New gasket for kit TK5194

CK5194

Gasket
OE #: 55515025

Issues with Opel 1.6 TCDi engines

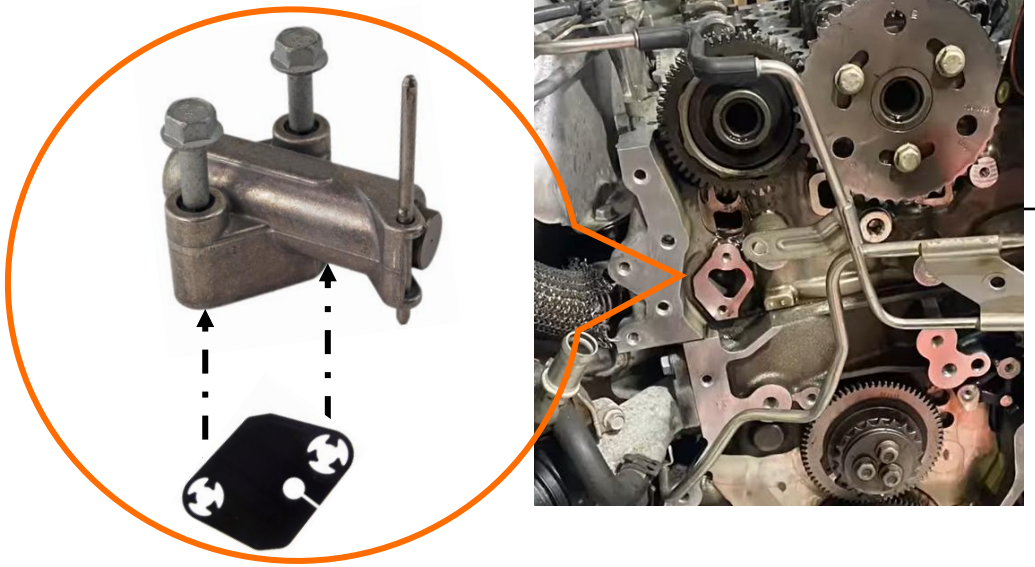
Rattling noise, especially when **cold** or during start-up, mainly caused by **loss of timing chain tension**.

- **Inefficient hydraulic timing chain tensioner**

The tensioner loses pressure due to oil leaking back into the oil sump.

The gasket supplied with kit KT5194 is installed between the timing chain tensioner and the engine block to ensure proper sealing and prevent oil leaks. It ensures that oil flow and pressure within the timing system are correctly maintained, preventing oil from escaping and avoiding possible hydraulic tensioner inefficiency.
